**SERVICE BULLETIN**

No. M 137A/4  
M 337/68

**CONCERNS :** Inspections and operation of the LUN 2221.13 starting magneto.

Obr. 1  
Fig.1 - Øxr.1

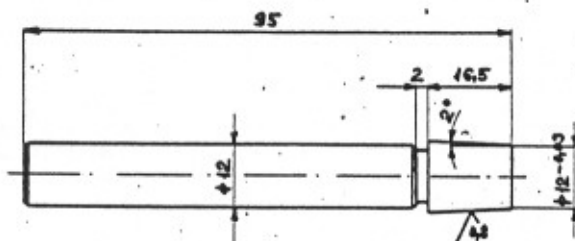
- 1) Check duly fixed fitting of the ignition distributor arm on the slit carrier pin of the distributor cam. This check is to be performed by trying to deflect radially the ignition distributor arm, however, in fact the arm is to be sufficiently fixed, not deflectable and not anyhow rocking. If the arm is found rocking, it is to be taken off and the carrier pin slit of the cam is to be slightly opened (it is recommended to use for this operation a mandrel illustrated in Fig.1)

Obr. 2  
Fig.2 - Øxr.2

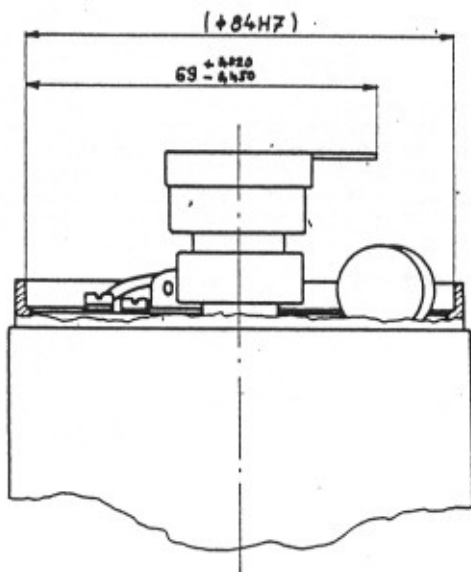
Then check the extend of pitting (burning) of the ignition distributor arm electrode in accordance with the attached Fig.2. The actual size is to be kept up within  $69^{+0,02}_{-0,45}$  mm. If the actual size is less than the specified one, the spark ignition distributing arm is to be replaced with a new one and recheck the size (see Fig.2) again.
